# Service Bulletin

## SAFETY RECALL

### 2002-2005 VFR800/A Wire Harness Replacement

## WIRING HARNESS & ROUTING INFORMATION

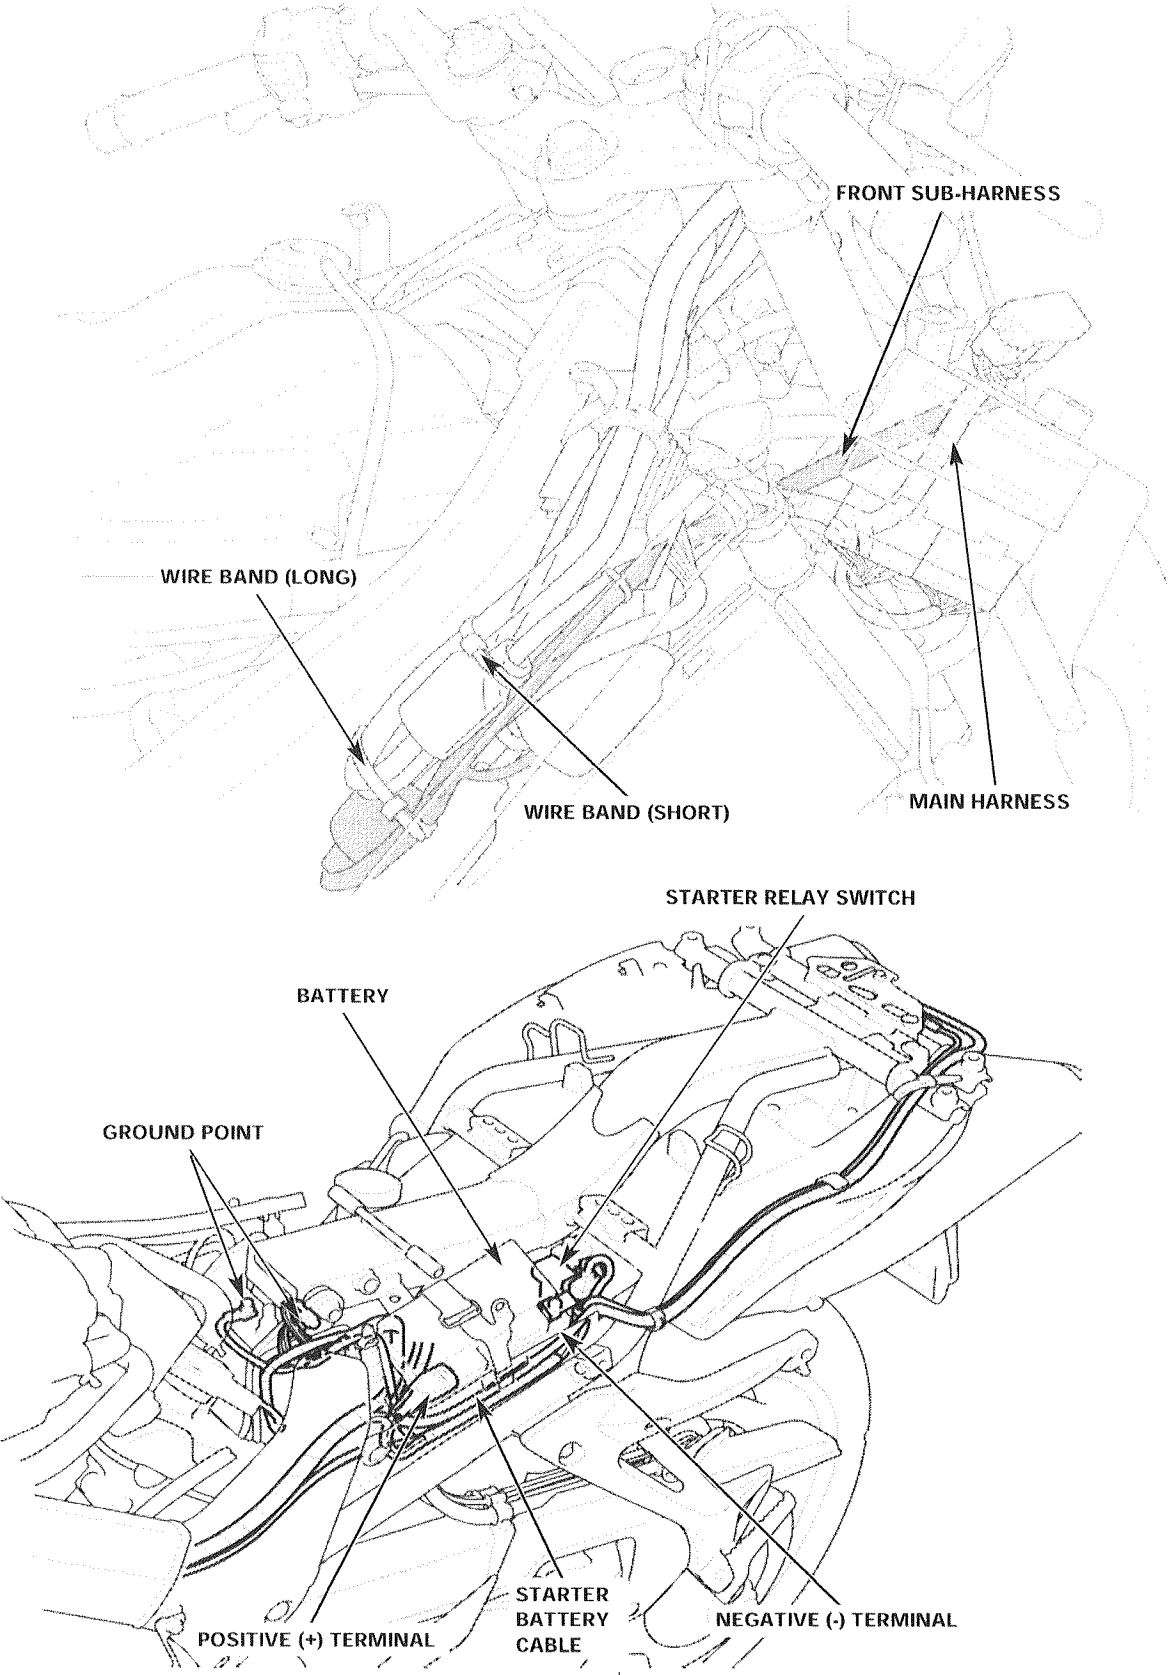
**NOTE:** For routing specifications, refer to the **WIRING & HARNESS ROUTING SECTION** on pages 7-8.

**MODIFIED WIRING DIAGRAM**  
**2002-2003 VFR800 (STANDARD TYPE)**

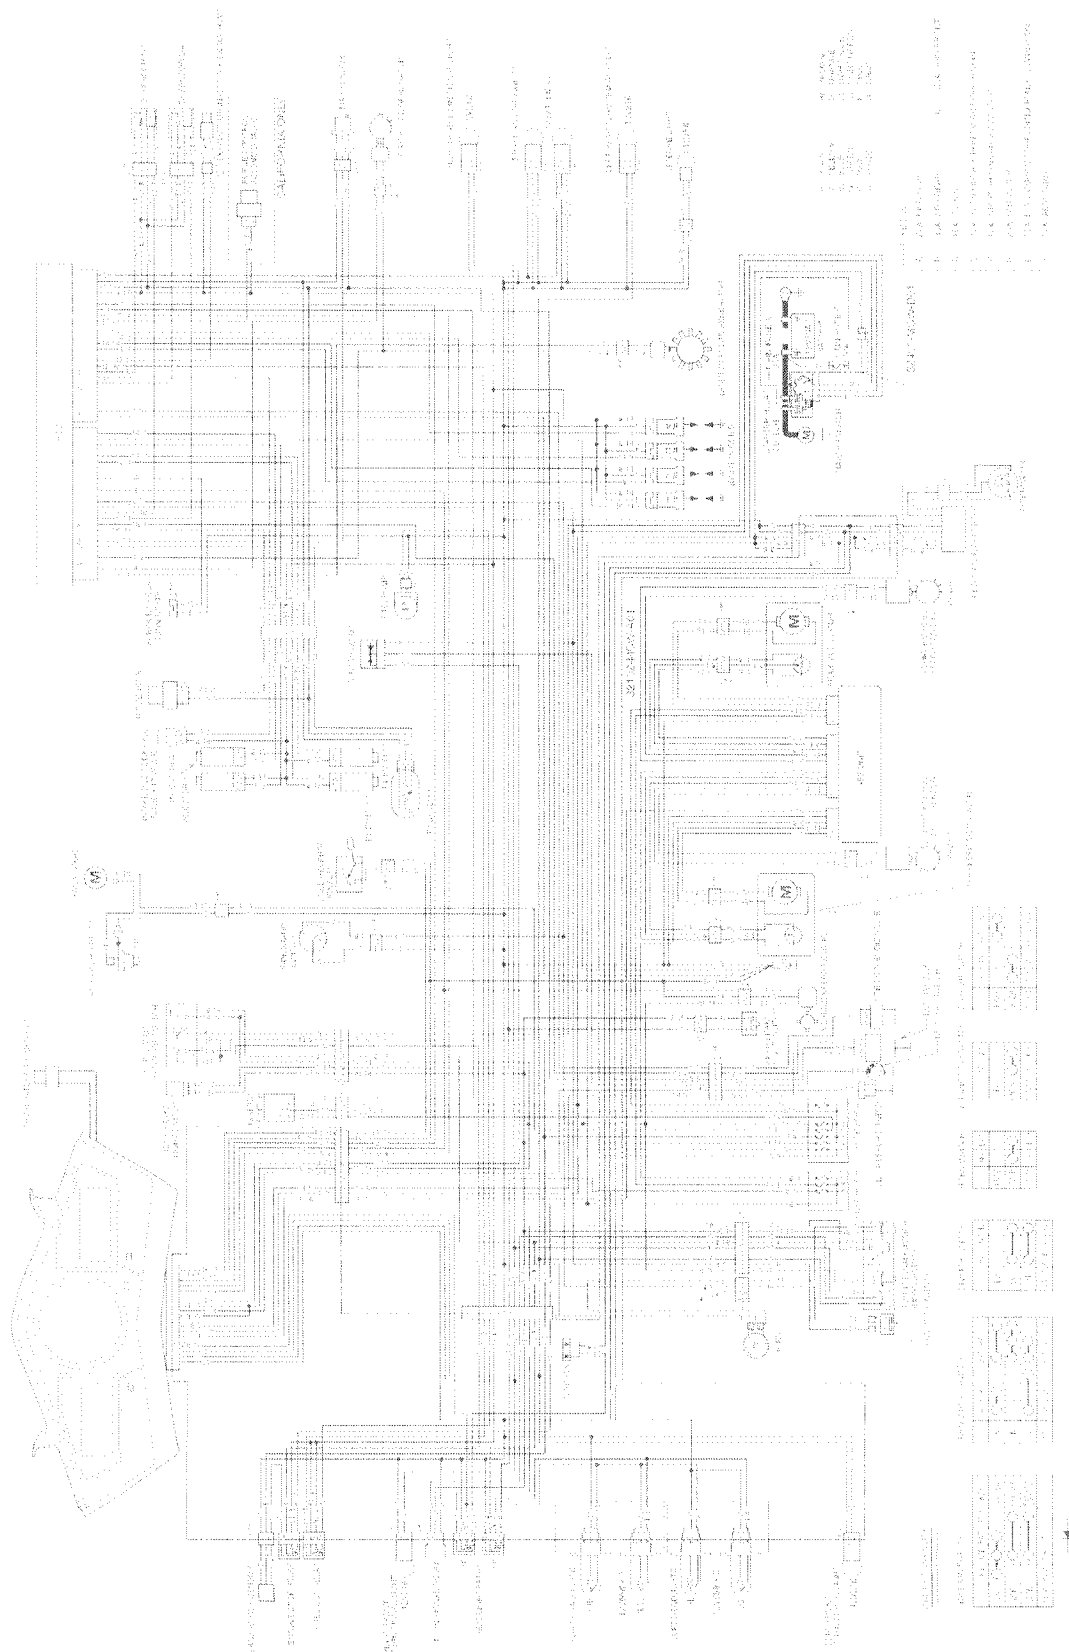
**NOTE:** Updated illustrations of the wiring diagram for the affected models are included with this Service Bulletin.
